**Statement of**

**Geoffrey H. Fettus  
Senior Attorney  
Natural Resources Defense Council, Inc.**

**“Oversight Hearing on 40 CFR §192, Health and Environmental Protection Standards for Uranium and Thorium Mill Tailings, Proposed Rule, 80 Fed. Reg. 4156-4187 (Jan. 26, 2015), Docket ID No. EPA-HQ-OAR-2012-0788.”**

**June 23, 2016, 10 a.m.**

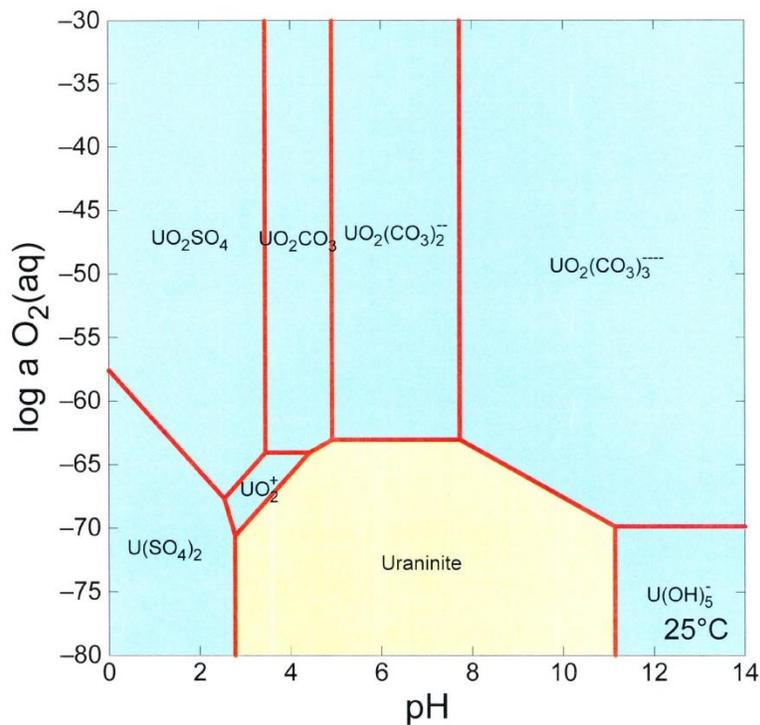
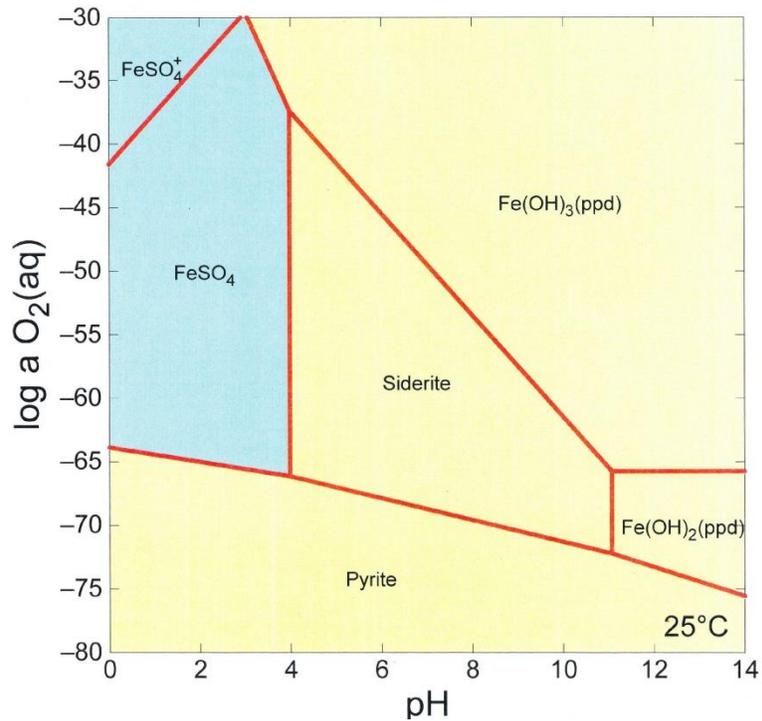
Below are Pourbaix diagrams displaying relevant geochemical conditions from Geochemist Workbench®. The top figure shows Iron and bottom figure shows the uranium stability fields.

The addition of a lixiviant and complexing agent to a reduced uranium ore creates a violent oxidation process which significantly alters the geochemistry and hence the solubility of uraninite in solution. These two conditions are signifying the incredible change in chemistry due to addition of lixiviant. The figure below, first produced today for these comments, demonstrates the theoretical change in uraninite solubility when no oxygen is present (solid red line) and when oxygen and carbonate is added to the model (dashed red line). The gray region approximates the geochemical conditions present when ore is extracted from the production zone. This significant change in geochemistry should make it apparent to EPA that there are substantial differences between pre-mining, original conditions and post-restoration conditions that have much less to do with the natural mineralized state of the water.

FIGURE 2

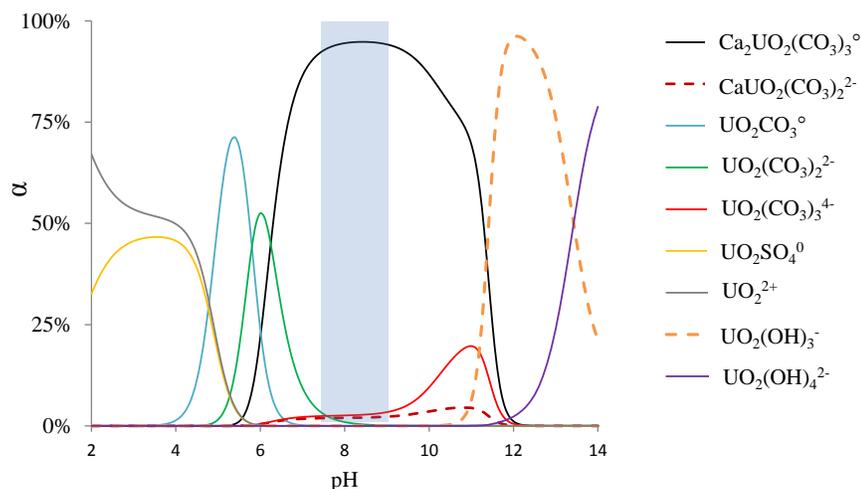
We've created the figure below using a geochemical modeling software (PHREEQC v.3.1.2) using an updated thermodynamic database which includes the formation of the  $\text{Ca-UO}_2\text{-CO}_3$  complexes and representative average stability data from Christensen Ranch ISL mine unit 5. The pH was the master independent variable and average post-restoration constituent concentrations were held constant. The shaded grey region shows the range of measured pH values from the stability samples at Christensen Ranch. The table below the figure shows the input data into the thermodynamic database and model. This figure shows, unequivocally, that the representative geochemical conditions in the aquifer post-restoration are largely dominated by  $\text{Ca-UO}_2\text{-CO}_3$  complexes predicted by the updated thermodynamic database. This evidence demonstrates that NRC and industry are using outdated assumptions about uranium geochemistry and transport, and EPA should, at a minimum, incorporate the updated science into its reasons for the rule. .

FIGURE 4: A) COMPARISON OF BASELINE AND STABILITY MONITORING FOR CHRISTENSEN RANCH MINE UNITS 2-6 AND B) CUMULATIVE HISTOGRAM OF GROUNDWATER URANIUM CONCENTRATIONS

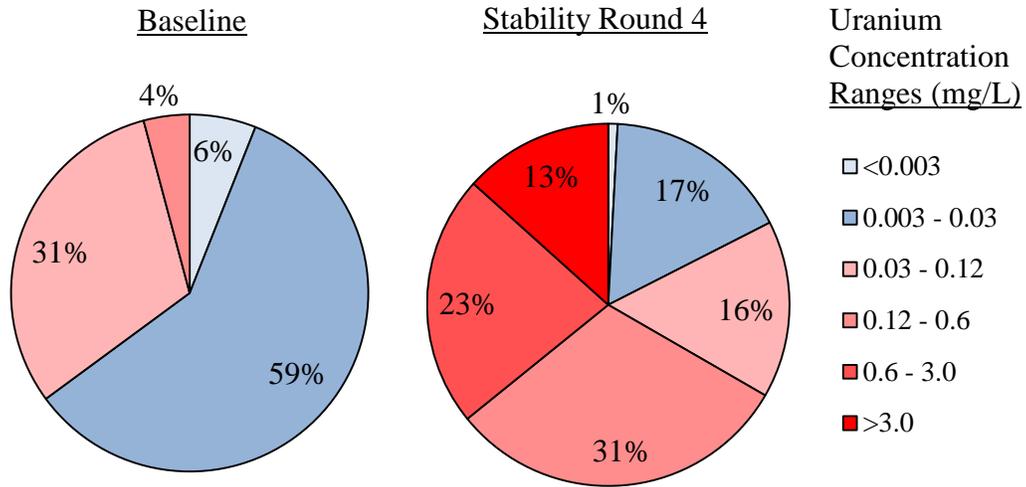
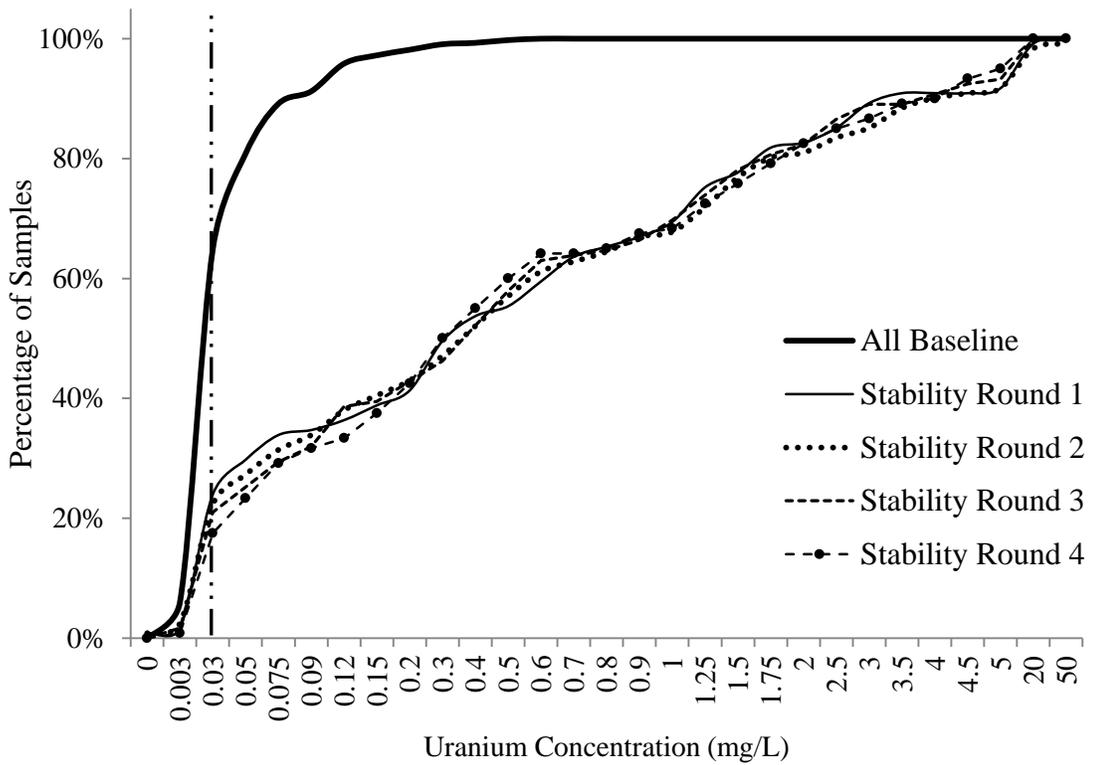
We provided a cumulative histogram for groundwater data from the Christensen Ranch ISL site (Figure 4; Comment #57). The results demonstrate that approximately 65% of all baseline samples (n = 433) were <0.03 mg/L, 31% were between 0.03 – 0.12 mg/L, and 4% were between 0.12 - 0.60 mg/L (Figure 4A). After ISL and groundwater operations at Christensen Ranch, the groundwater quality distribution observed substantially elevated uranium concentrations. Post-Restoration stability sampling round 4 results observed approximately 18% of the groundwater sample were <0.03 mg/L, 47% between 0.03-0.60 mg/L, and two new categories of elevated uranium concentrations were observed which

observed 23% of samples were 0.6 - 3.0 mg/L, and 13% were >3.0 mg/L (Figure 4A).

Examining the groundwater quality distribution cumulatively for each post-restoration round circumvents issues with sporadic data trends for a given well (Figure 4B). The data suggests that the groundwater quality distribution across all mine unit samples display little appreciable temporal changes. If natural attenuation mechanisms were substantially decreasing the net uranium mass in groundwater, the post-restoration data distribution trends would progressively trend back to the baseline distribution. However, there's little difference between round 1-4 stability sampling distributions, suggesting the net groundwater uranium mass is staying relatively constant throughout the stability sampling period.

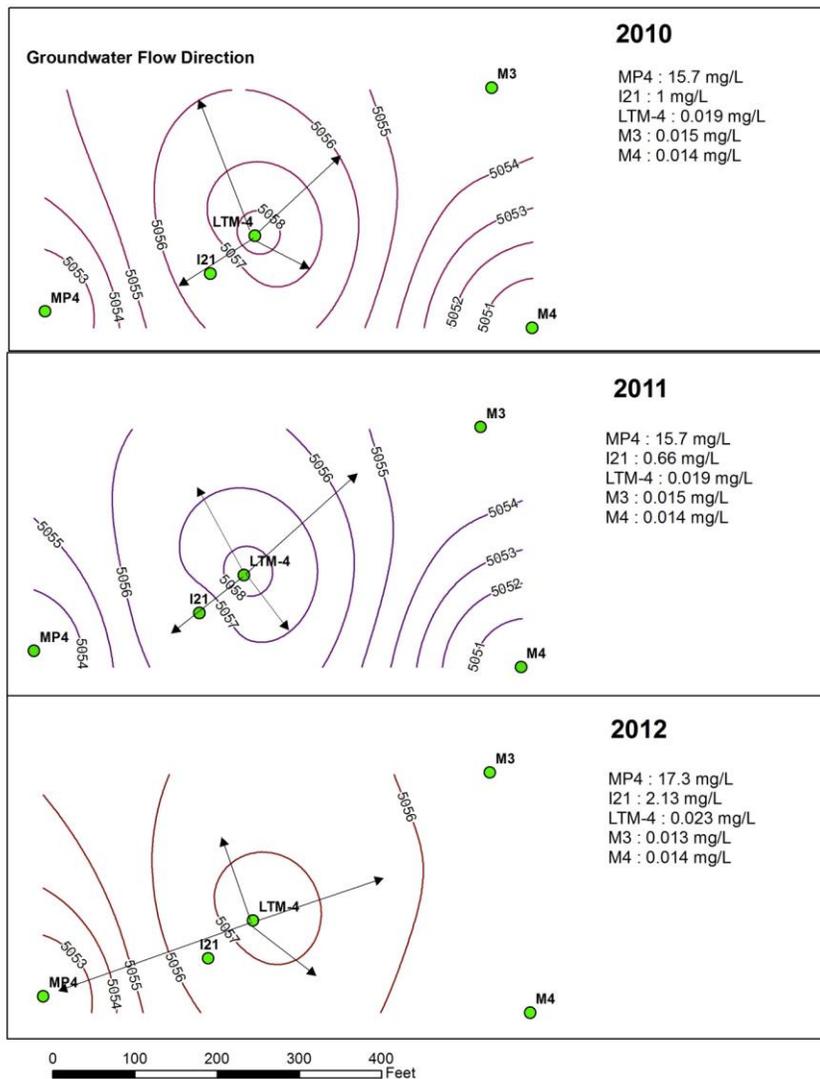
However, the 'water level' data<sup>142</sup> suggest that the groundwater flow direction was moving away from LTM-4, not towards it (Figure 8). According to hydrogeology, groundwater flows from high to low potentiometric surface.

With this information regarding the science and history of fluid excursions, EPA's rule must require all ISL sampling, throughout all stages of operations, to include proper sampling methods, quality control, and sample documentation before it accepts *any* groundwater samples. Furthermore, these analytical sampling techniques *must be required* in accordance with EPA guidelines) or scientific based Standard Methods). The use and reliance of an unknown, inconsistent, and inadequate analytical technique does not support a scientifically defensible excursion monitoring program and calls in to question much of the assumptions of 'slow', 'lock-in', or 'naturally attenuated' uranium transport behavior. In other words, if uranium is not detected, above an extremely high detection limit, then industry and regulators will be able to assume that it is lagging behind the lixiviant plume. This is not consistent with the empirical data, nor the current understanding of the non-reactivity of Calcium-uranyl-carbonate complexes.
